SAN FRANCISCO PLANNING DEPARTMENT

DATE: July 11, 2008
TO: Interested Parties
FROM: Joan A. Kugler, Senior Environmental Planner
RE: CASE NO. 96.281E: CENTRAL SUBWAY PROJECT (PHASE 2 OF THE THIRD STREET LIGHT RAIL PROJECT) COMMENTS AND RESPONSES

RESPONSE TO COMMENTS
VOLUME II
**FINAL SUPPLEMENTAL ENVIRONMENTAL IMPACT STATEMENT/
SUPPLEMENTAL ENVIRONMENTAL IMPACT REPORT**

FIGURE 2-16

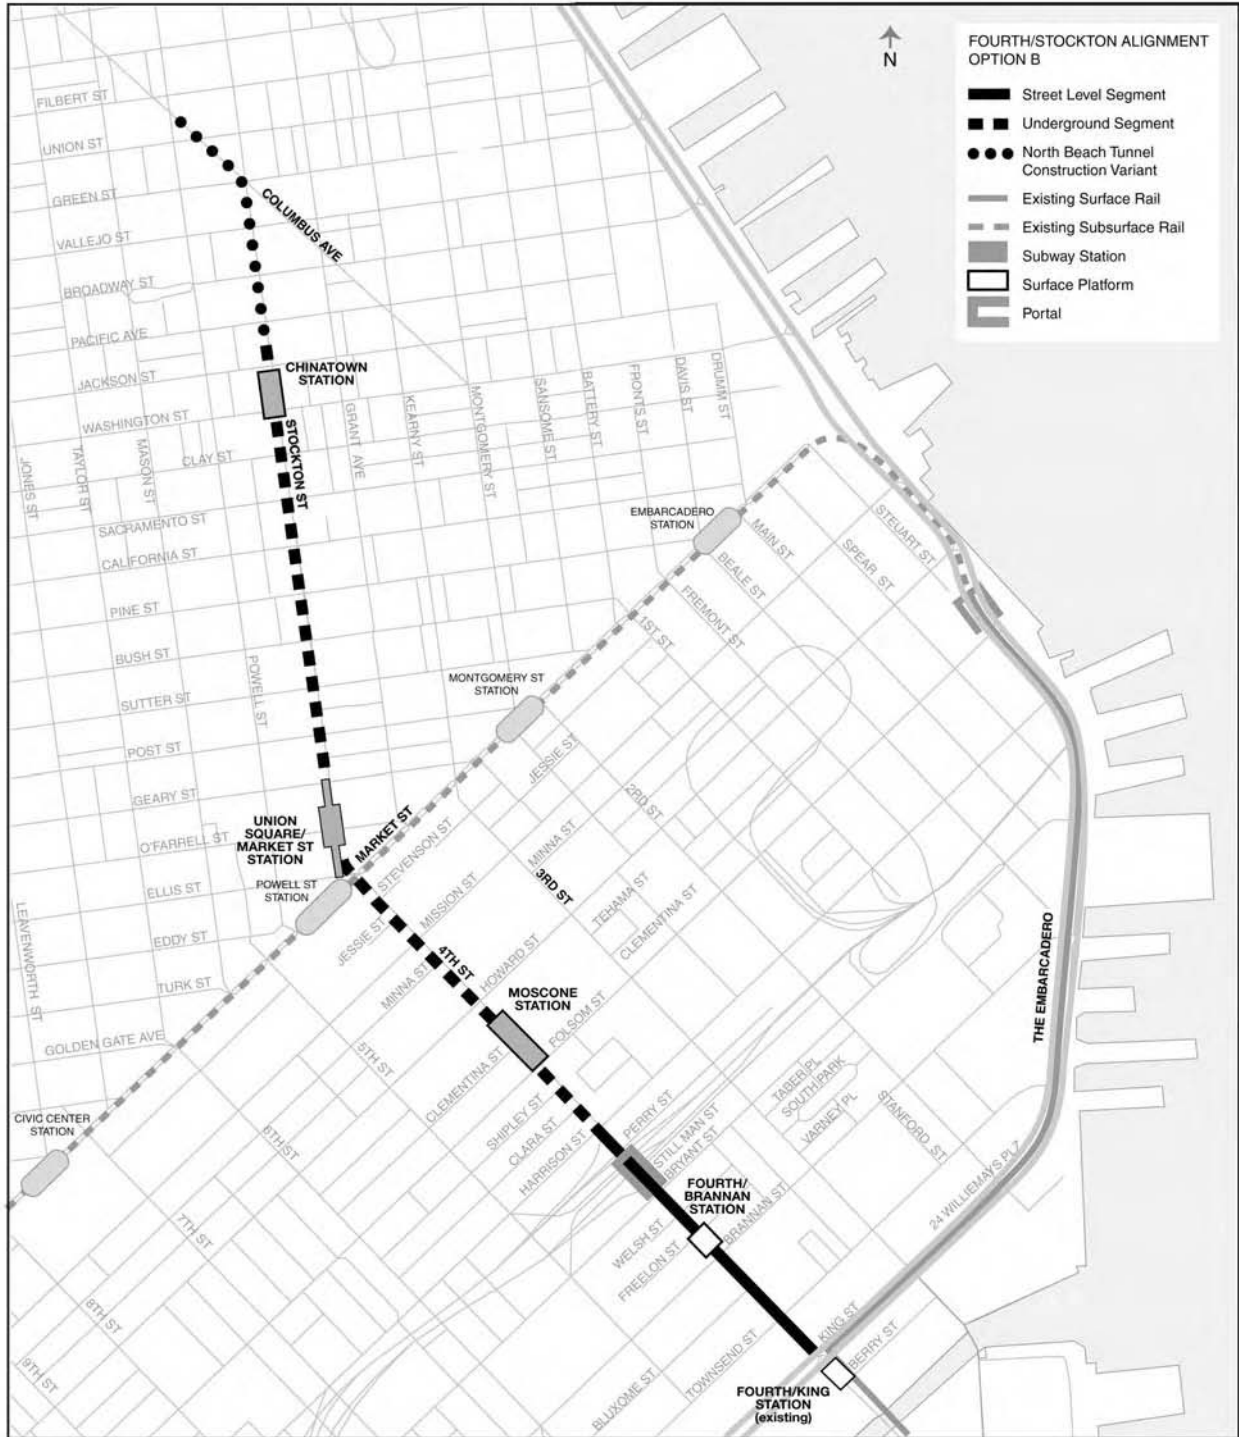
Our current schedule anticipates that the area east of Fourth Street between Perry and Stillman will be improved during and put into service prior to completion of the Central Subway construction activities on Fourth Street under the I-80 viaduct. Traffic impacts generated by construction in this area could affect bus movements and the operation of the T.J.P.A. Bus Storage facility. Specific mitigation measures that would allow buses to access the bus storage area during construction should be identified and described separately from other mitigations that propose traffic detours to avoid construction impacts unless these measures would also accommodate bus movements into and out of the bus storage area.

A crash barrier is planned for the portal to protect the entrance structure from turning buses. The current tunnel portal layout plans provide space for the tunnel crash barrier without interfering with the turning path of the bus as it enters the bus storage facility. Figure 2-18 on page 2-39, Figure 2-19 on page 2-41, and Figure 5-10 on page 5-40 have been revised to show the tunnel crash barrier. See Response to Comment R-1 for revised figures.

“After stopping at the station platform on Fourth at King Streets, light rail would continue north on Fourth Street to a double-track portal between ~~Bryant Perry~~ and Harrison Streets under I-80 (see Figure 2-16).”

Figures 2-16, 2-18, 2-19 and 5-10 are revised as noted in the attached pages to reflect the relocation of the subway portal and the placement of a crash barrier.

Figure 4-4

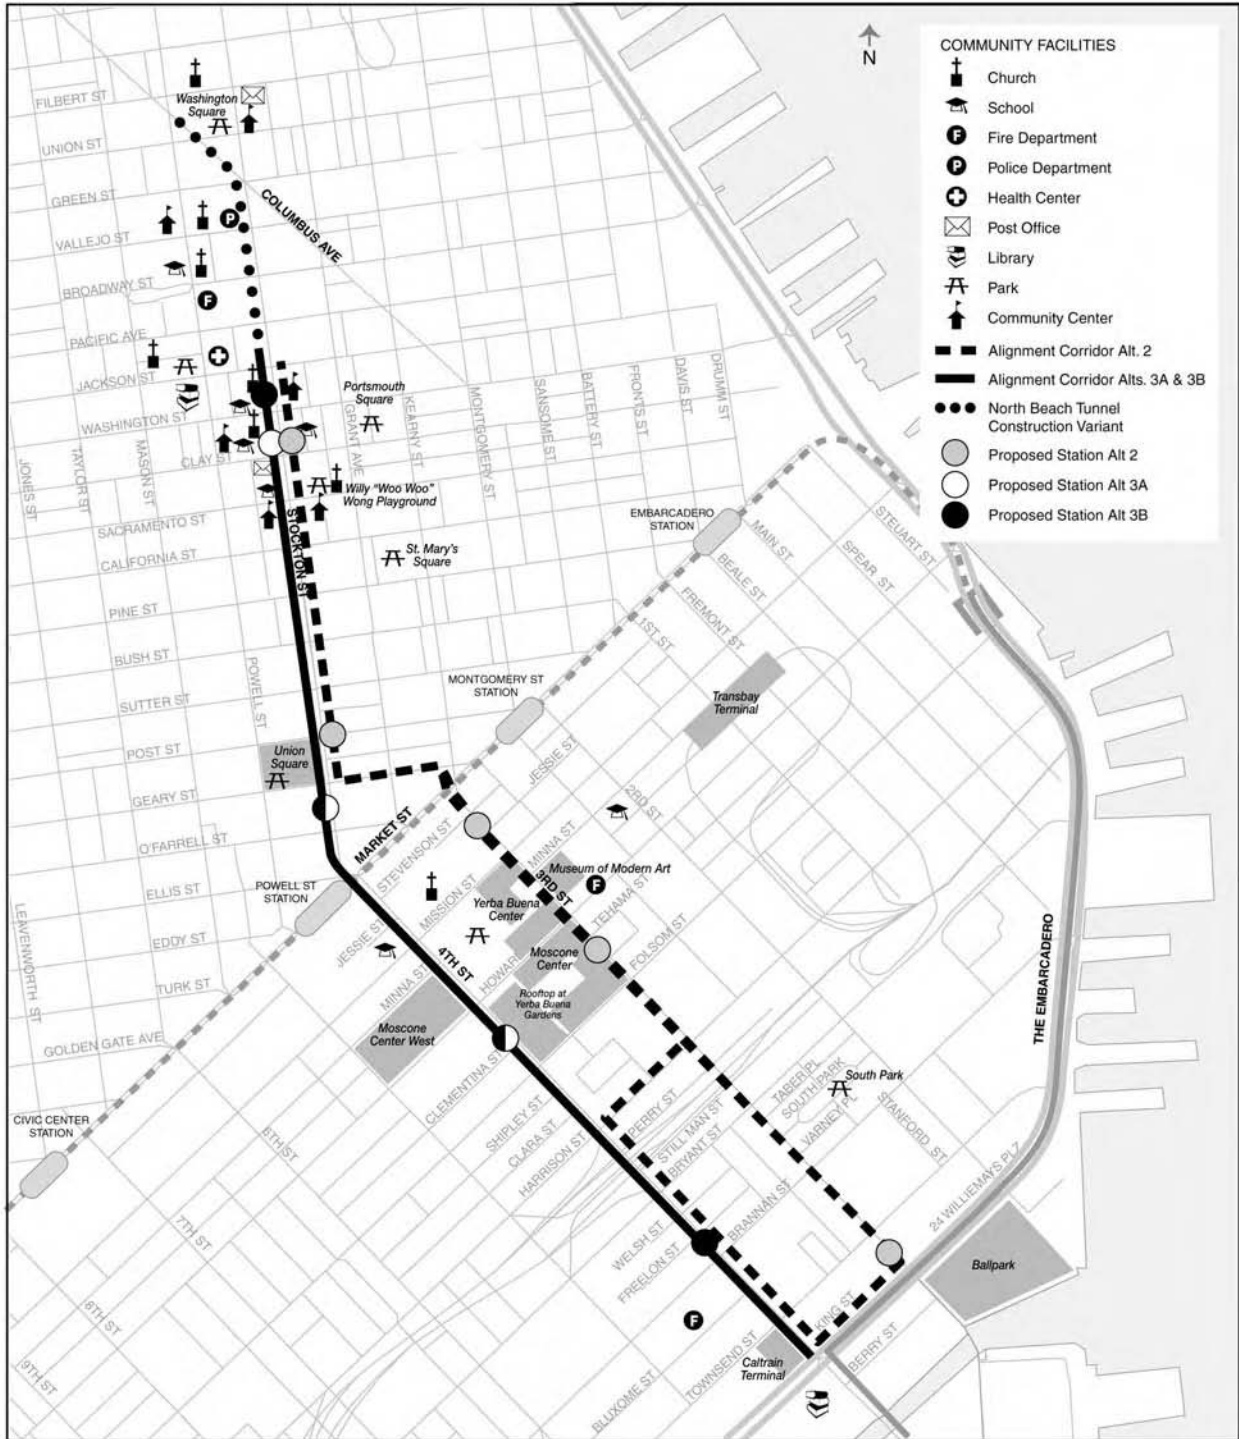
Chinese Hospital	845 Jackson	Private	Medical services
Cumberland Presbyterian Chinese Church	865 Jackson	Private	Presbyterian church
Station 2	1340 Powell	City	Fire house
Gordon Lau Elementary School	950 Clay	SF Unified School District	Elementary School
Salvation Army Chinatown Corps	1450 Powell	Private	Sunday school, senior center, community center
Central Police Station	766 Vallejo	City	Police station
Cathay Post #384 American Legion	1524 Powell	Private	Veterans association
Pin Yuen Senior Recreation Center	799 Pacific	Private	Senior center
San Francisco Chinese Baptist Church	1524 Powell	Private	Baptist church
Chinese United Methodist Church	1009 Stockton	Private	Methodist church

Figure 4-4 on page 4-36 is amended to include the Chinese Historical Society, Donaldina Cameron House, Chinatown YMCA, First Chinese Baptist Church, and Presbyterian Church in Chinatown.
